Shop Drawing Submittal Review

Project Name: Webster University-**ISB**

Copies	No.	Description
1 PDF	224216P02	(Submittal No.'s)
		(Cannon #22 4216.16-001) - (Paric #15051-) – (WES #607)
		➢ **Commercial Sinks**
		• Clinical Service Sink CSS-1
		• Scrub Sink SS-1
		• Sink SK-1
		• Garbage Disposer GD-1
		• Sink SK-2
		• Sink SK-3
		• Mop Sink MS-1
		• Kitchen Sinks KS-1, KS-2, KS-3

PROJECT NAME:	Webster University ISB
LOCATION:	St. Louis Missouri
CLIENT PROJ. NO.:	N/A
WES PROJ. NO.:	607
SPEC SECTION:	22 4216.16 Commercial Sinks
SUBMITTAL ITEM:	See Below -

SCR1B/ SCR09/ SCR19/ SCR39/ SCR49 Multi-Turn Angle Stop w/ Loose Key – Compression x Compression

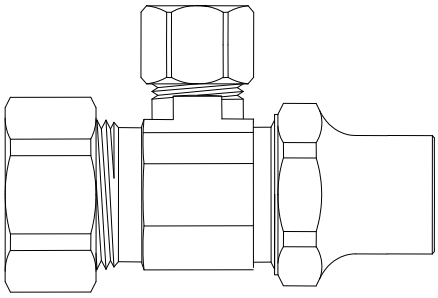
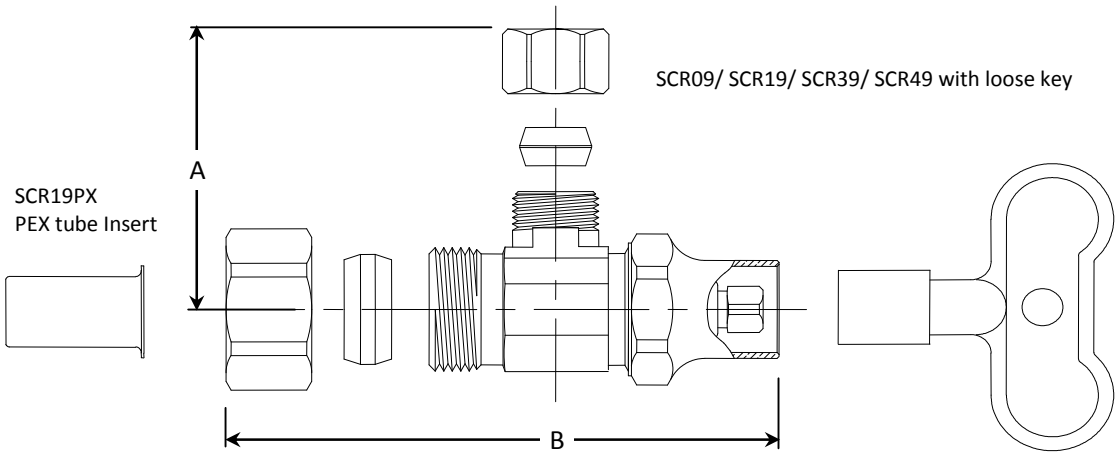
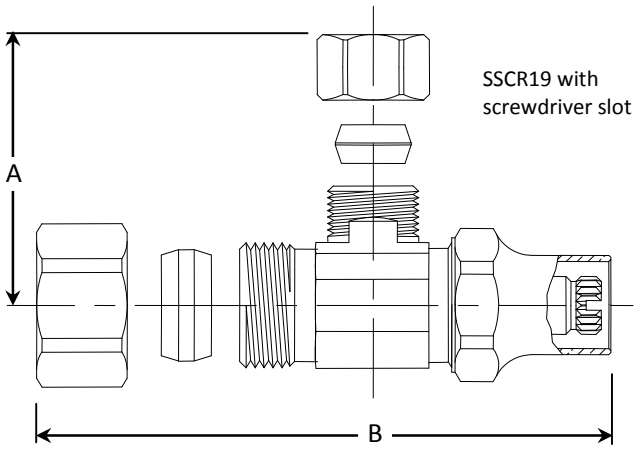
1. Provide under counter waste and supply protective piping covers as required. Verify requirements with the architectural drawings.
.
2. Escutcheons are specified to be cast brass. Refer to specification section 220518.
